Comments of the Keweenaw Bay Indian Community in Opposition to the Issuance of an Underground Injection Control Permit to Kennecott Eagle Minerals Company (Application No. MI-103-5W20-0002)

Prepared for:
Keweenaw Bay Indian Community
16429 Bear Town Road
Baraga, MI 49908

Ann S. Maest
Stratus Consulting Inc.
PO Box 4059
Boulder, CO 80306-4059
303-381-8000

Figure 4.14. KEMC's conceptual hydrogeologic cross section, Eagle Project, through the Yellow Dog Plains and the Negaunee Moraine to the north.

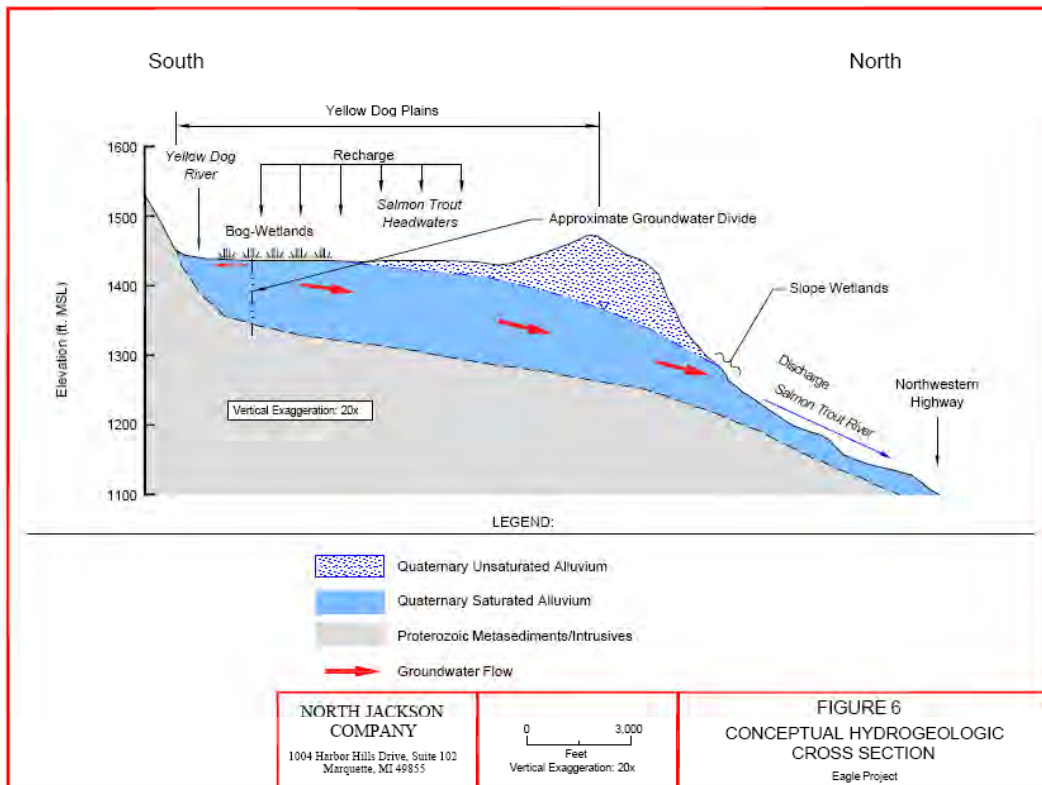
KEMC did provide several conceptual hydrogeologic or geologic cross-sections through the TWIS area, but they are inconsistent with site data (see Foth & Van Dyke, 2006b, Vol. 2, App. B-8, Figure 6 and App. B-1, Figure 6). For example, Figure 4.14 shows KEMC's suggested regional hydrogeologic profile through the Yellow Dog Plains and the Negaunee Moraine to the north. It fails to show bedrock flow, regional dikes, the peridotite dike, or major faults, all of which likely have pronounced effects on the hydrogeologic flow system. A realistic alternative is to show multiple dikes (south to north) where bedrock is elevated, thinning Quaternary deposits, and limited flow to the north. In the alternative conceptual model, flow would be directed to the east, or out of the page, draining instead eventually into the Yellow Dog River basin rather than the Salmon-Trout River basin. Given the lack of hydrogeologic information northeast of the TWIS, this conceptual model is at least as plausible as KEMC's. In fact, recent information supplied by KEMC shows that the dominant groundwater flow direction in the A zone is to the east (KEMC, 2008c).
